305 S. CONGRESS PUD

### COMMENT REVIEW REPORT

This report includes all comments received to date concerning your planned unit development. The planned unit development will be approved when all requirements identified in this report have been addressed. However, until this happens, your planned unit development is considered disapproved.

STREET SECTION A-A'  
SOUTH CONGRESS AVENUE EDGE CONDITION

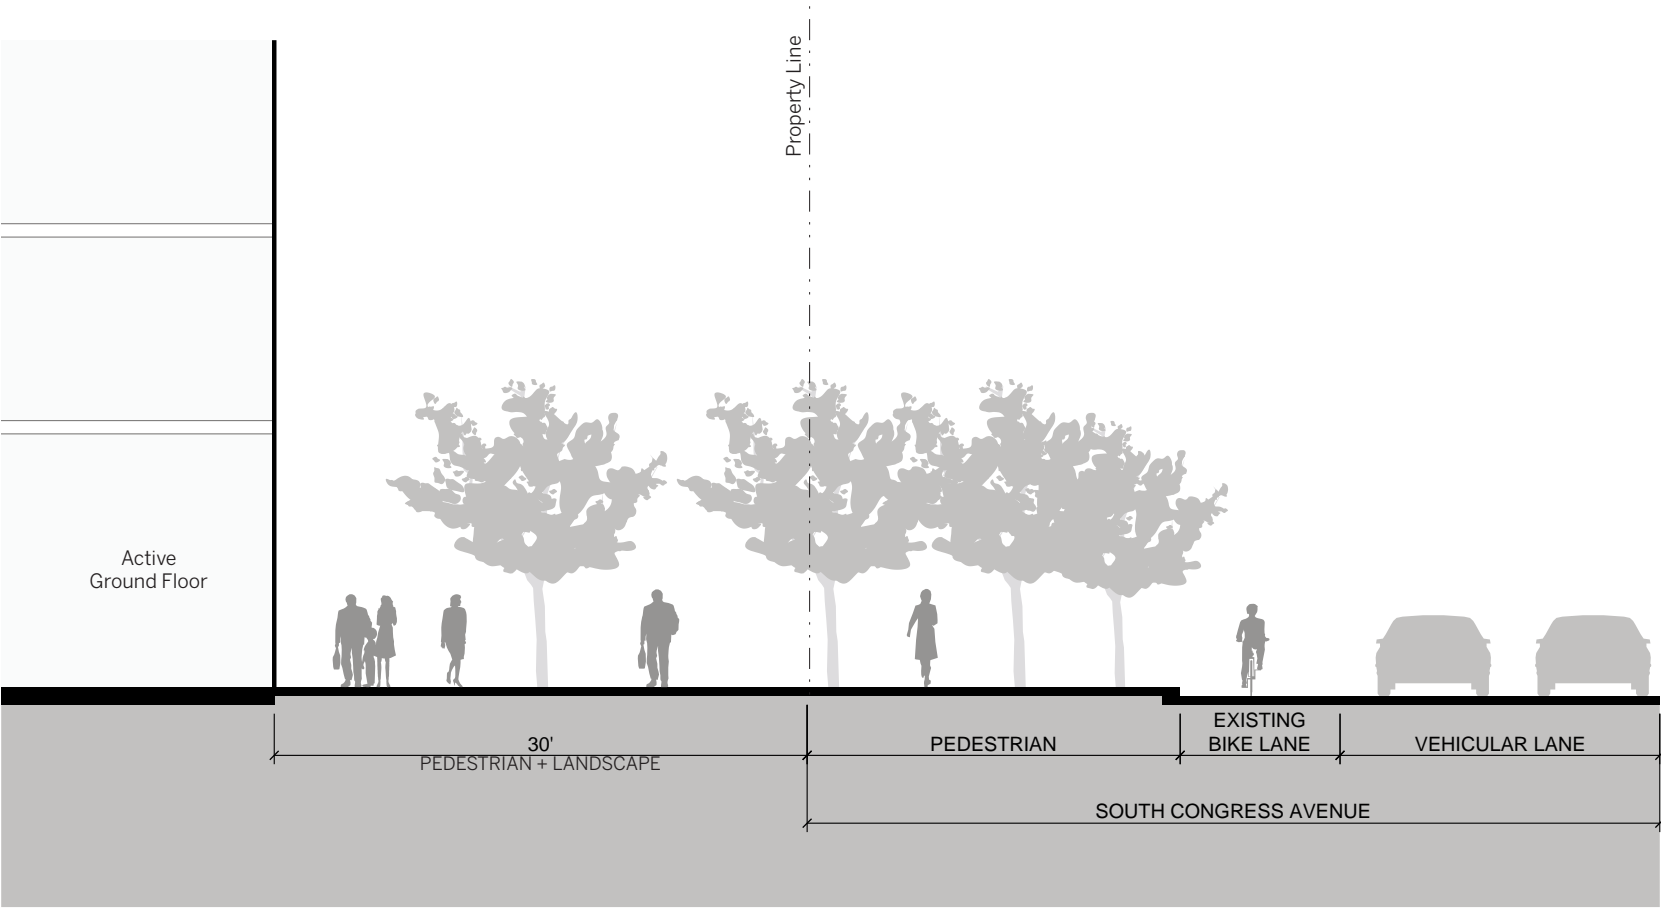
- ATD 5. Street Section A-A: No bike facility is shown in this cross section. The South Central Waterfront plan calls for **a 6'-6.5' raised bike lane behind a 2' buffer** along the east frontage of S. Congress. The ASMP identifies protected bicycle facility along Congress frontage as well. In order to meet the superior results expected from PUDs, the cross sections should at least meet the baseline set by ASMP.

**Update 2: The recently installed protected bike lanes must still be included within the cross section. PUD A-A cross section should mirror South Central Waterfront Plan for S. Congress (Core Transit Corridor):**

INTERNAL PVT DRIVEWAY SECTION C-C'  
ENTRY STREET TYPICAL SECTION 66' WIDE

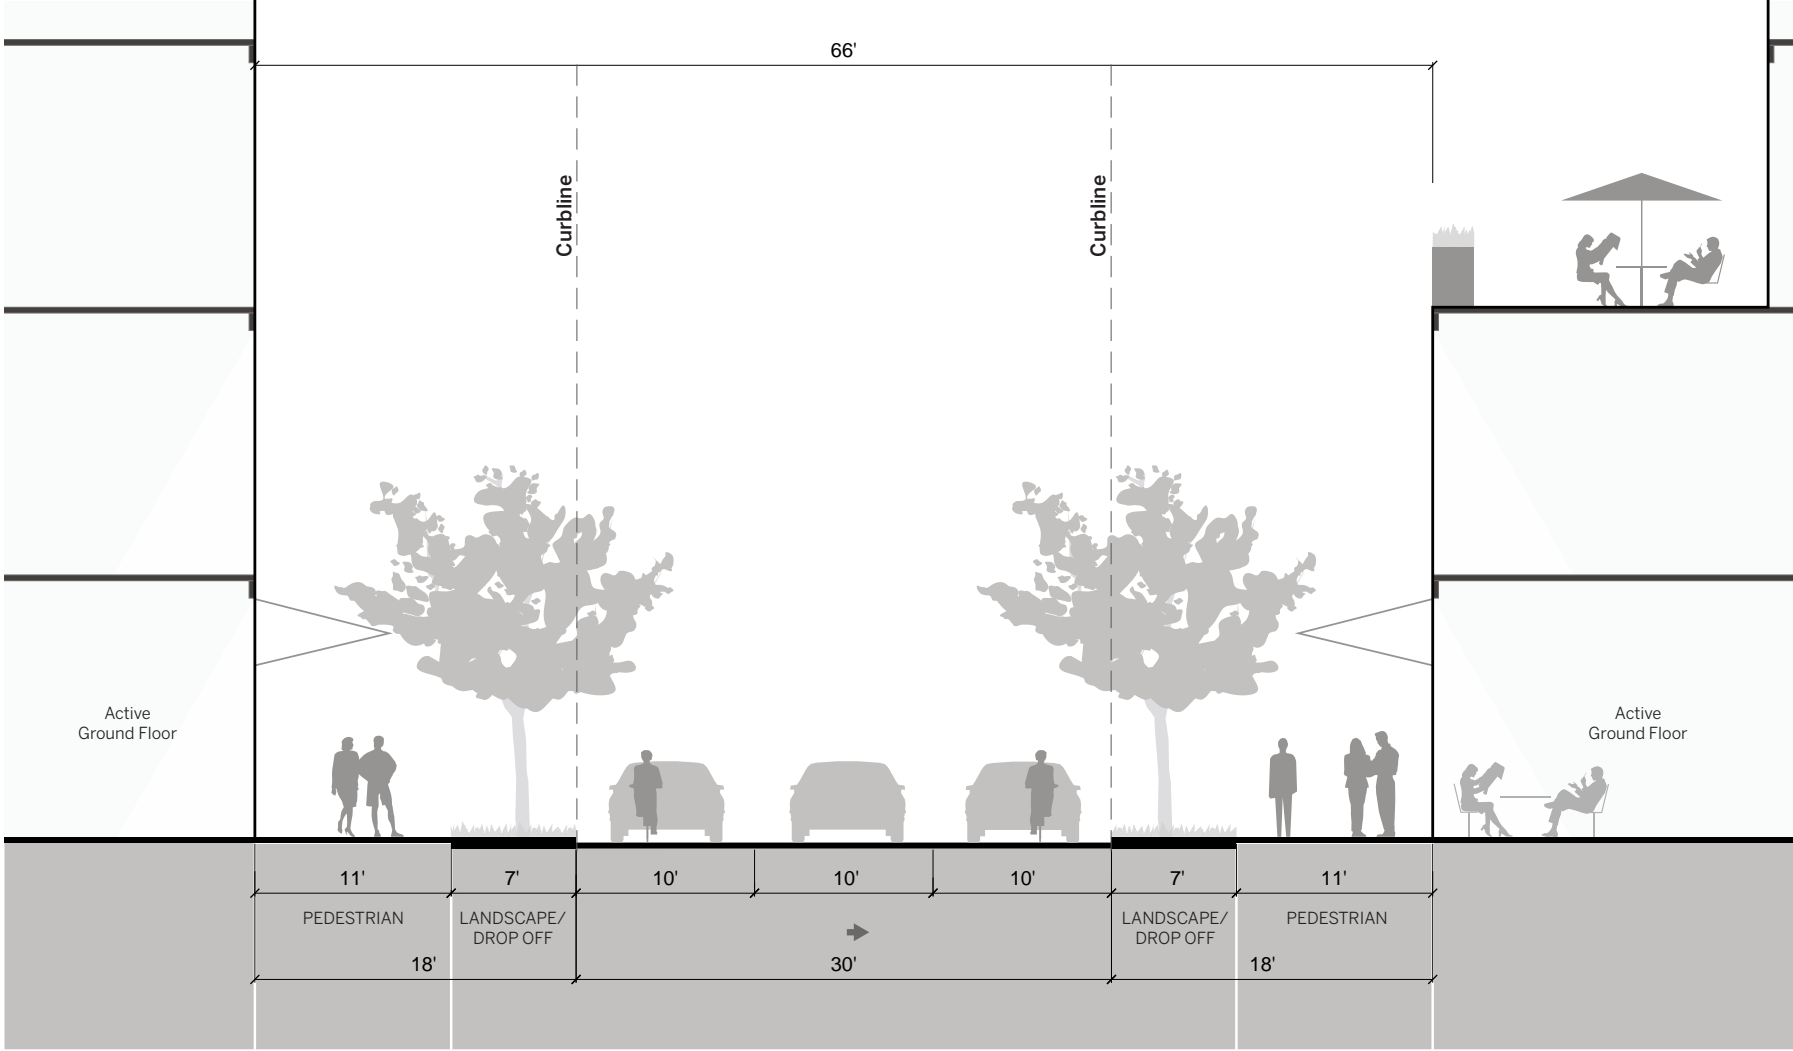
- ATD 6. Street Section C-C: ASMP calls for this to be a 2-lane street with all ages and abilities bike infrastructure. If this is planned to be a street with low volume (less than 3000 ADT), national best practice would make a simple 5' painted bike lane in each direction acceptable for this facility, which would fit within the roadway width indicated in the cross section. If higher vehicular volume is planned, a protected bicycle lane would be necessary to be an all ages and abilities facility.

**Update 2: If 5000+ VTD are anticipated, protected bike lanes are required. The South Central Waterfront Plan requires min. 5' bike lanes (see "Local Street" cross section from SCWP below):**

INTERNAL PVT DRIVEWAY SECTION D-D'  
SHARED STREET TYPICAL SECTION 66' WIDE

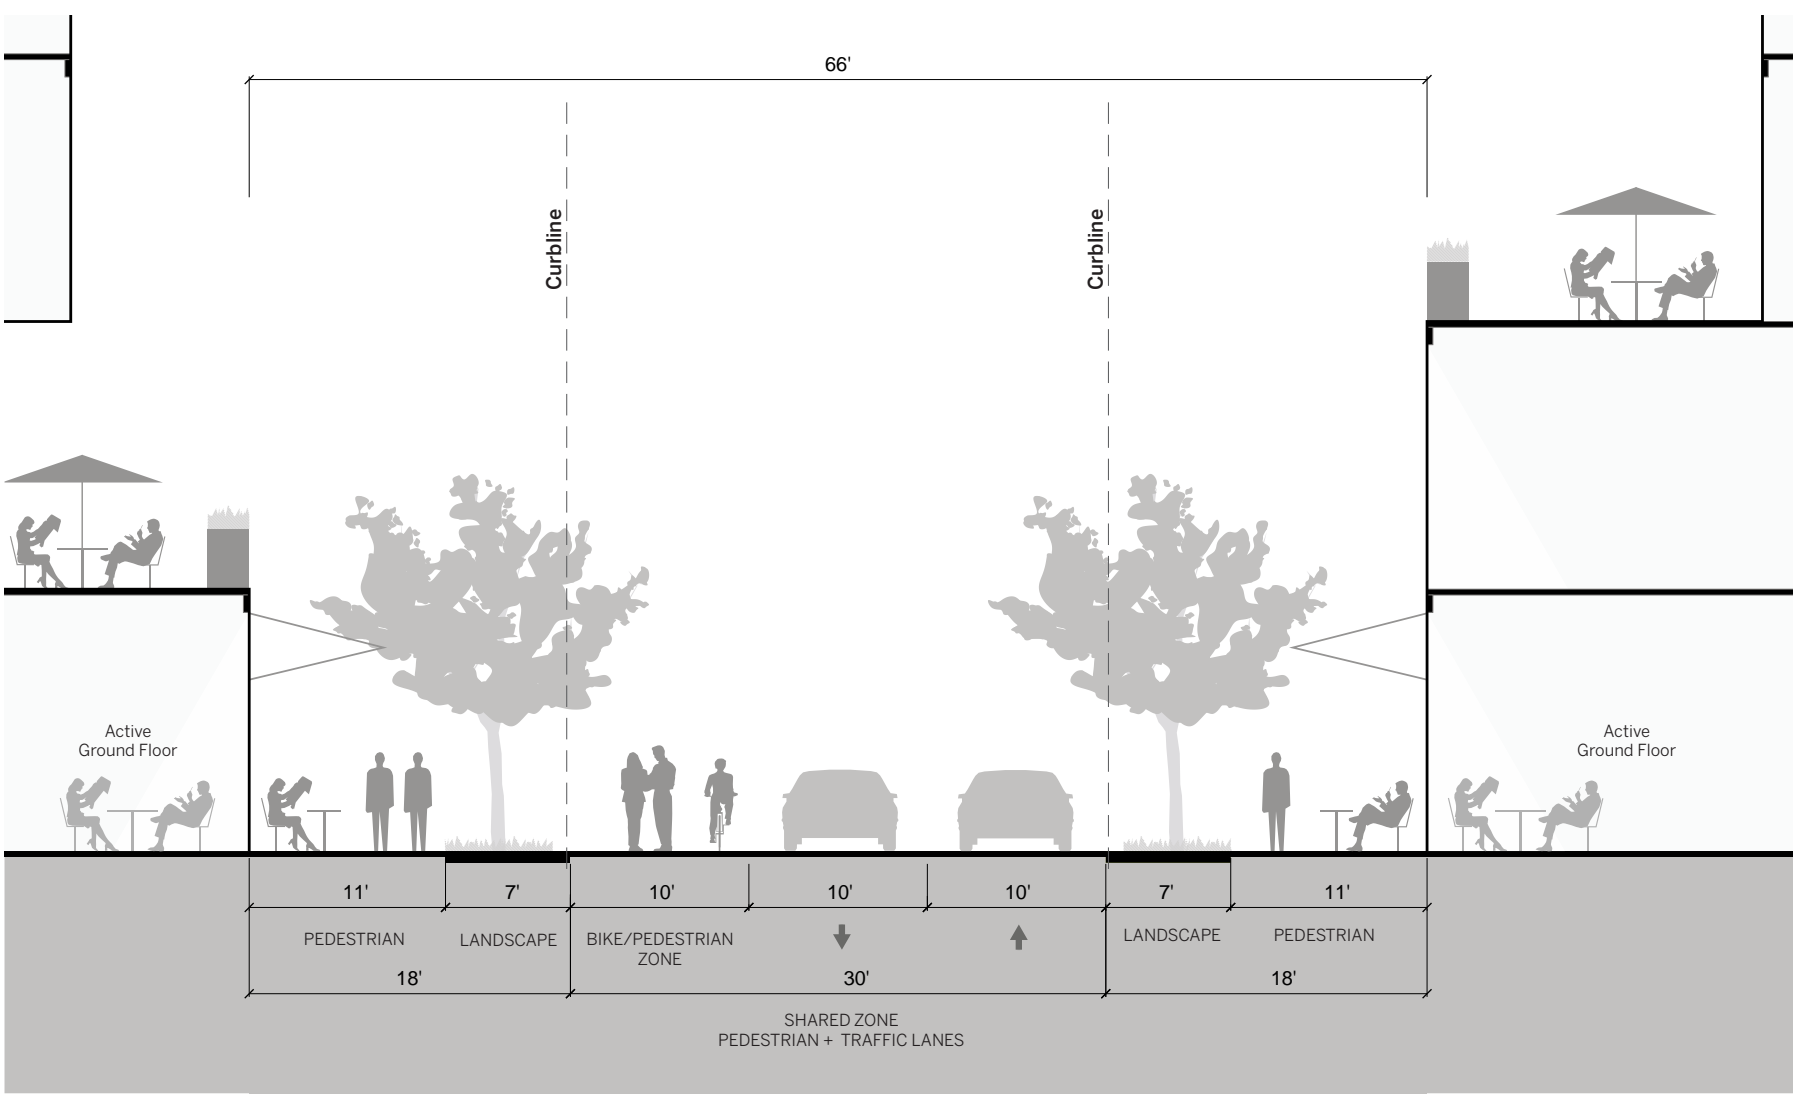
- ATD 7. Street Section D-D: ASMP calls for this to be a 2-lane street with all ages and abilities bike infrastructure. If the space shown in the cross section is intended as a two-way cycle track, it should be shown that way with vertical separation from vehicular travel space. If that is the

case, 10' would be very constrained given the context of a possible future pedestrian bridge. Recommend 12' minimum width plus a barrier.

**Update 2: The SCWP identifies a 12' cycle track with 1' buffer as needed for this shared street. Comment pending further internal review.**

PEDESTRIAN WALKWAY TYPICAL SECTION E-E' 45' WIDE

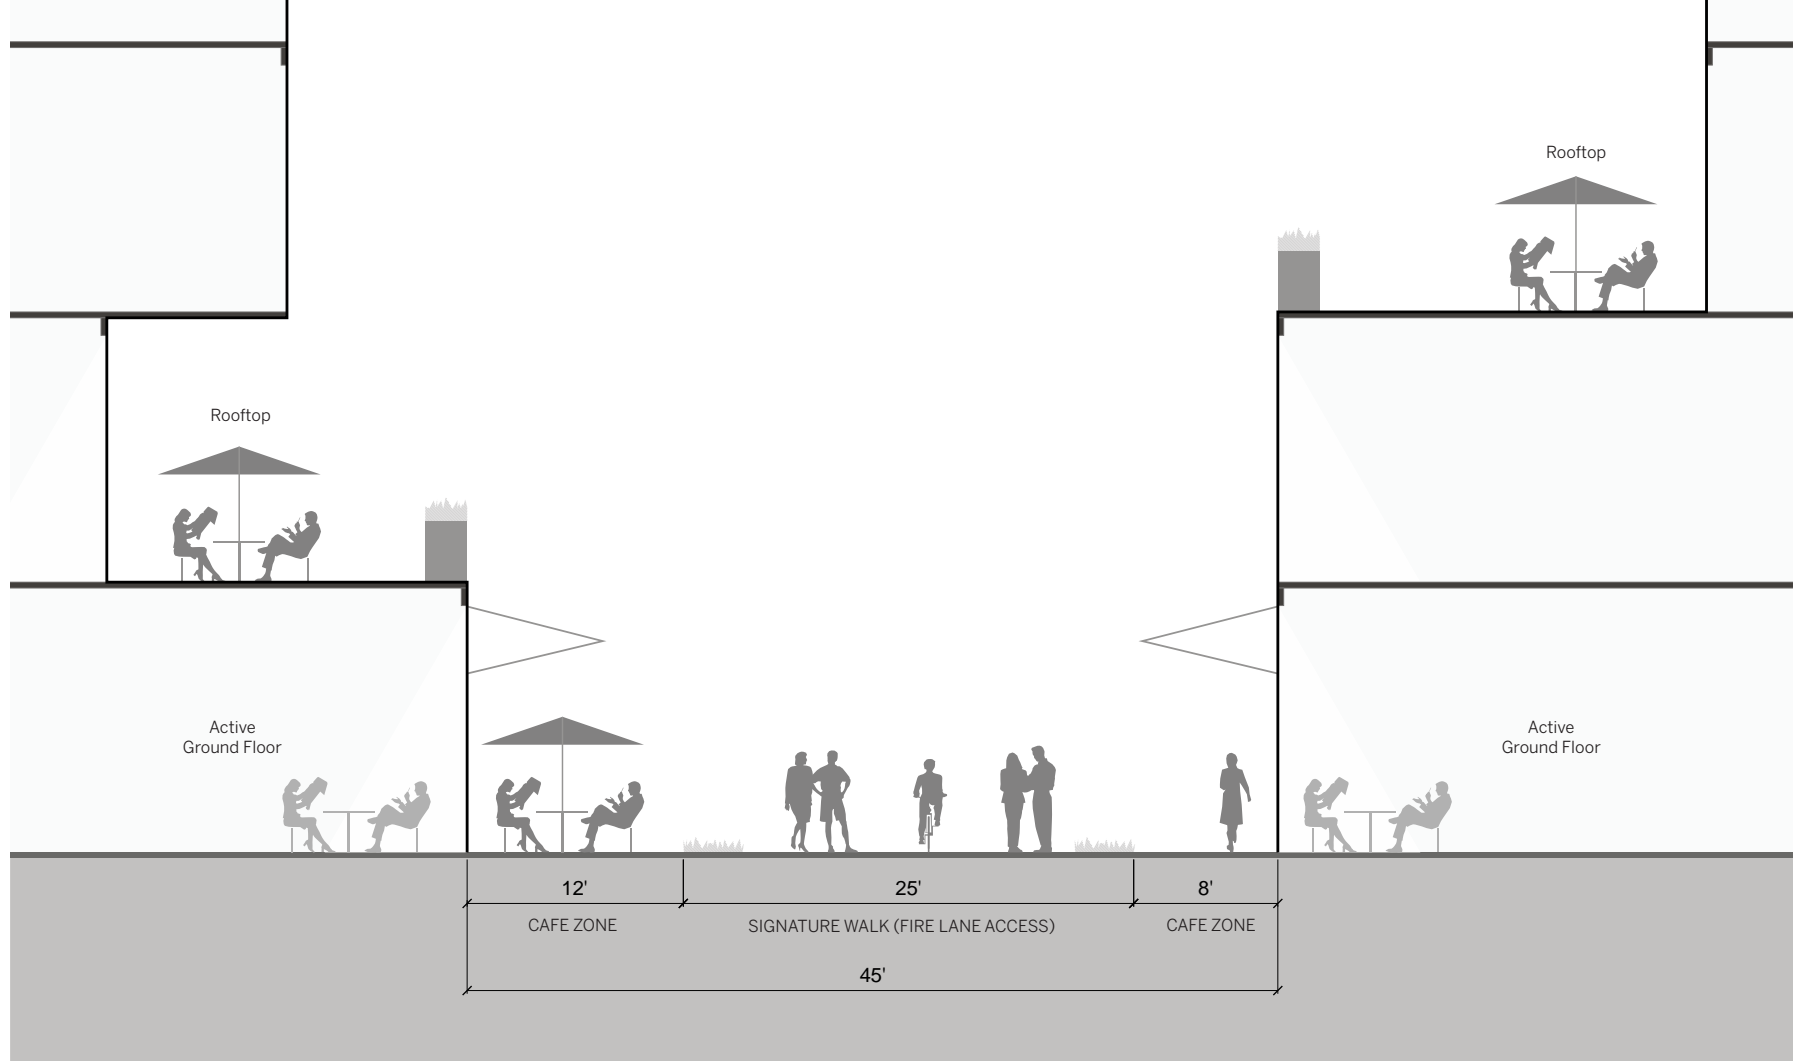
- ATD 8. Street Section E-E: There should be actual tree zones identified on this cross section as this would otherwise be a wide unshaded area. If this will be used as fire access, AFD will want 25' clear at designated deployment zones, but trees could be planted inside this 25' but outside of those small deployment zones. It needs to be made explicit in the exhibit that this street section will be closed by bollards so that it does not become an extension of the shared street to the east or used for loading zones.
